DAIFUKU TEST BUILDING JSP19-13

Consideration at the request of Northern Equities Group for Preliminary Site Plan and Stormwater Management Plan approval. The subject property is 10.28 acres located in Section 1 of the City of Novi and located north of Thirteen Mile Road and east of Cabot Drive. The applicant is proposing to construct a 1-story research and testing building, consisting of 24,100 square feet, on the east side of the property. The site previously received approval for a 76,549 square foot office building for Daifuku North America Holding Company’s headquarters, which has been constructed.

PLAN REVIEW CENTER REPORT

March 18, 2019 (revised 4-10-19)

ORIGINAL ISSUE DATE:
 FEBRUARY 18, 2019
 PEA JOB NO: 2019-086
 SCALE: 1" = 20'
 DRAWING NUMBER:
 L-1.1

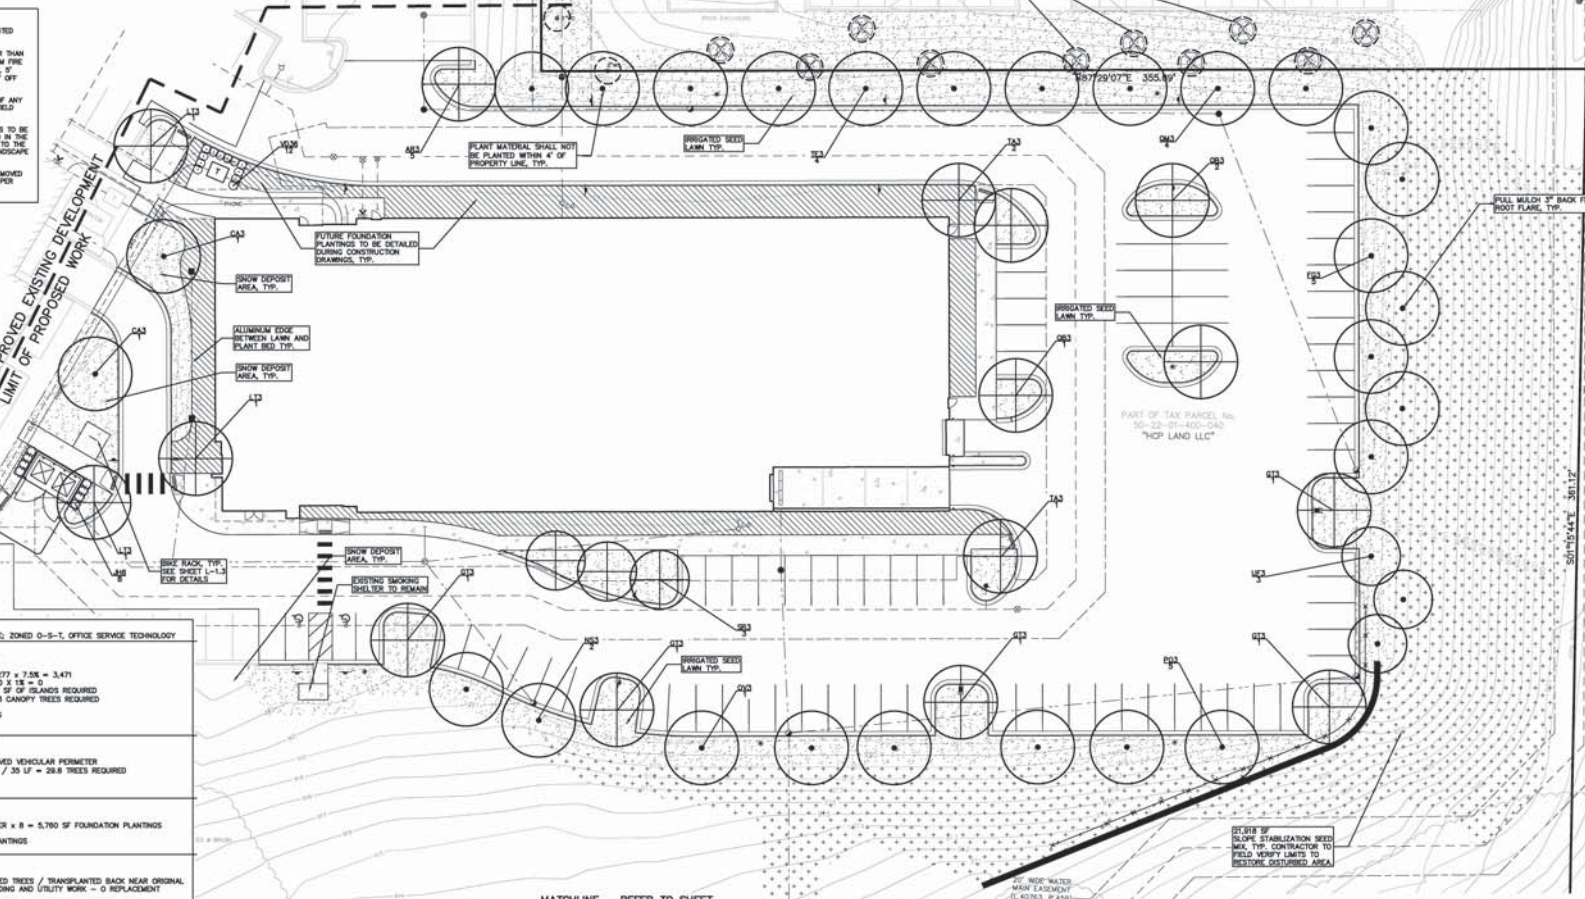
1. Provided.
2. The island at the southeast corner of the building does not appear to be wide enough to provide 10 feet between the tree and hydrant, 4 feet between the tree and sidewalk, and 3 feet between the tree and curb. **Please adjust the island size and/or hydrant location to allow all required trees to be planted with the required spacing.**

1. **Please provide an existing conditions sheet that shows all trees on and within 50 feet of the project area.**
2. **Please clearly show all existing trees to be removed and to be saved.**
3. **Please provide tree fencing around all trees to remain that aren't being transplanted.**

Figure 1. City of Novi Regulated Wetland & Woodland Map (approximate project boundary shown in red). Regulated Woodland areas are shown in green and Regulated Wetland areas are shown in blue.

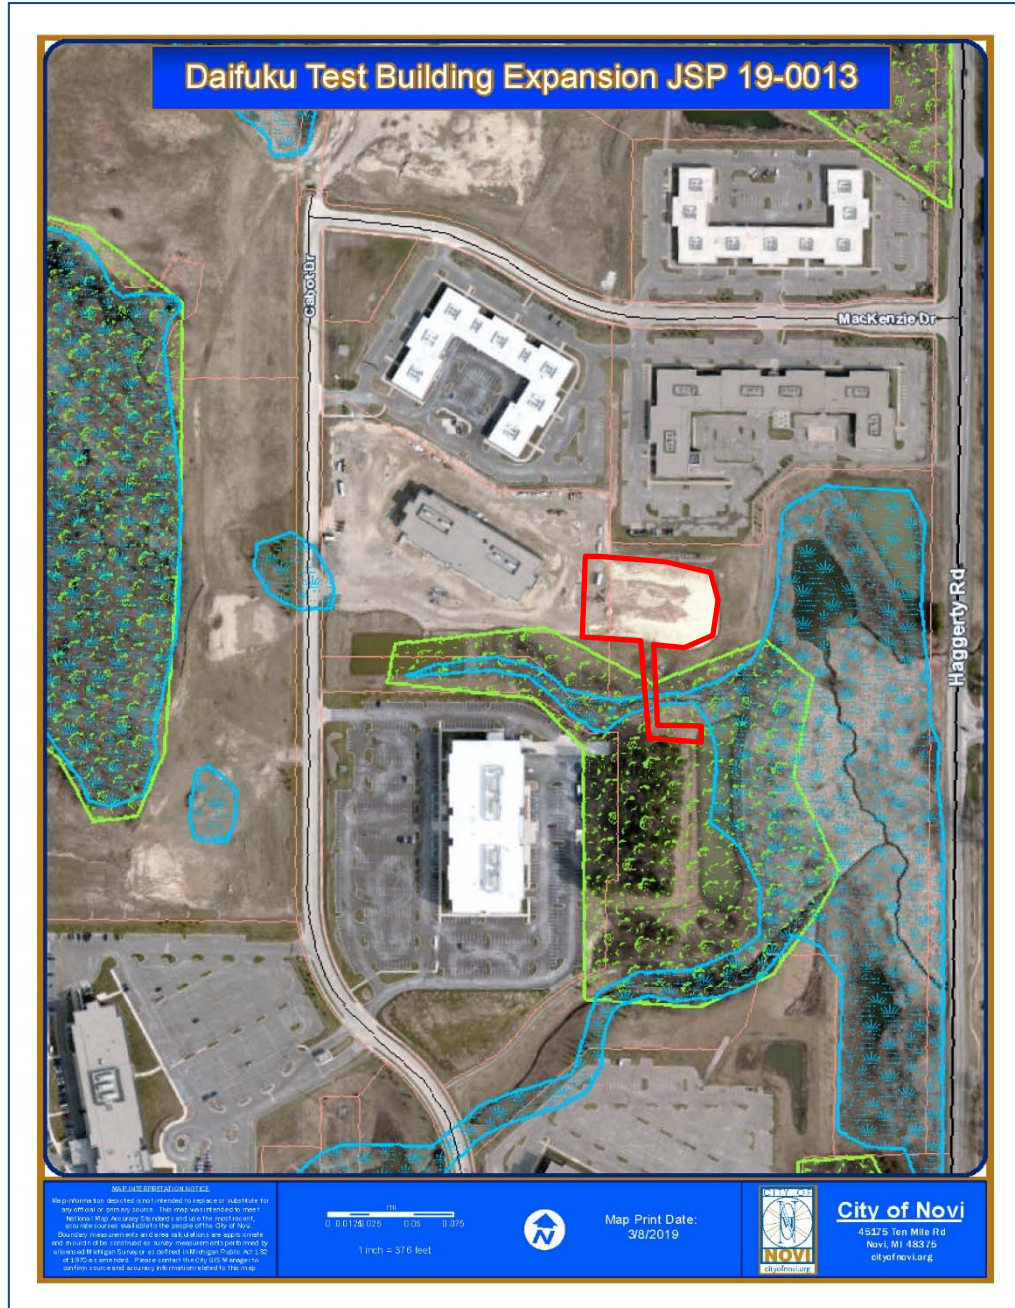
Based on our review of the application, Novi aerial photos, Novi GIS, the City of Novi Official Wetlands and Woodlands Maps (see Figure 1, attached) it appears as if the overall project limits contain both City-Regulated Wetlands and Woodlands.

An existing stream/drain (indicated as 'stream' on the Plan) is located at the south side of the subject parcel (tributary to the Seeley Drain). The drain is located within a currently wooded area south of the main area of site construction; partially located on the project property. This area is indicated as both Regulated Wetland and Regulated Woodland on the City of Novi Regulated Wetland and Woodland Map (see Figure 1). It should be noted that the 25-foot natural features setback should be indicated on the Plan around this stream as well as around Detention Basin 'B'.

ECT has reviewed the City of Novi Official Regulated Wetlands Map but has not completed an onsite wetland evaluation at this time. ECT recommends that we conduct a wetland field verification in order to verify existing regulated wetland/watercourse boundary locations with respect to the limits of the proposed project. It shall be the applicant's responsibility to clearly indicate the limits of proposed disturbance in the field prior to any such site inspection. The wetland and/or watercourse boundaries shall also be delineated and flagged on-site by a professional wetland consultant if this has not already been done. It may be the case that the "stream" boundary as indicated on the Plan is the edge of the wetland/watercourse and there is no additional wetland area 'fringe' associated with this drain.
